S/035/0050

Glen Wood Gravel Pit

GEOJPG.gif
464K

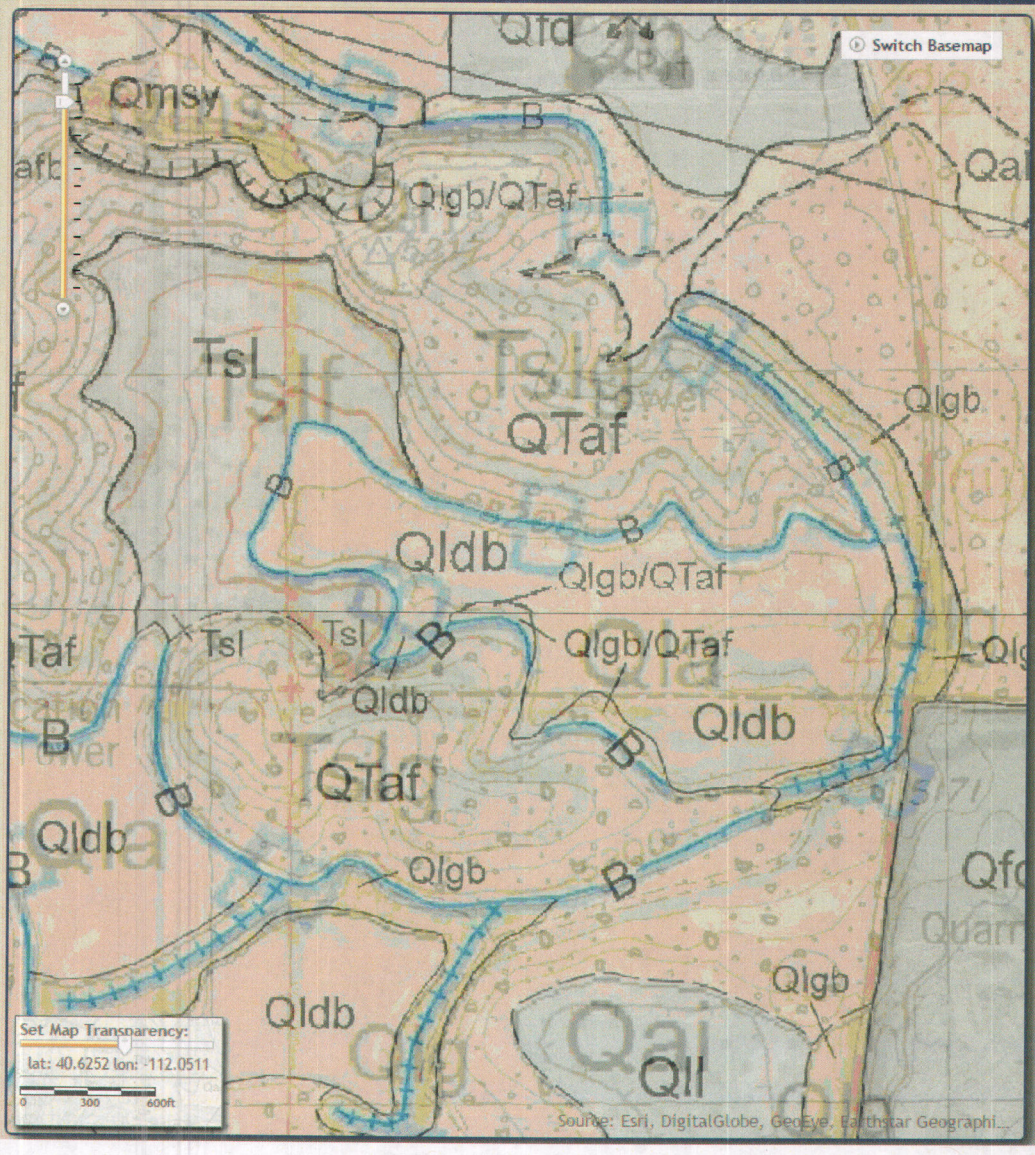
Please find attached a screen shot of the geology map from your Proposed Glenwood permit. The majority of the area is mapped as Tertiary aged Rock - mixed volcanic tuff and marl, silt and sandstone. Which explains the radio tower being on a topographic high in the area and rock fragments being subangular in the area. (versus subround or rounded). You were correct on submitting a permit to OGM.

Please keep in mind the volcanic portion of the rock is high in feldspar, and feldspar will weather over time to clay, if you plan is engineered fill material.
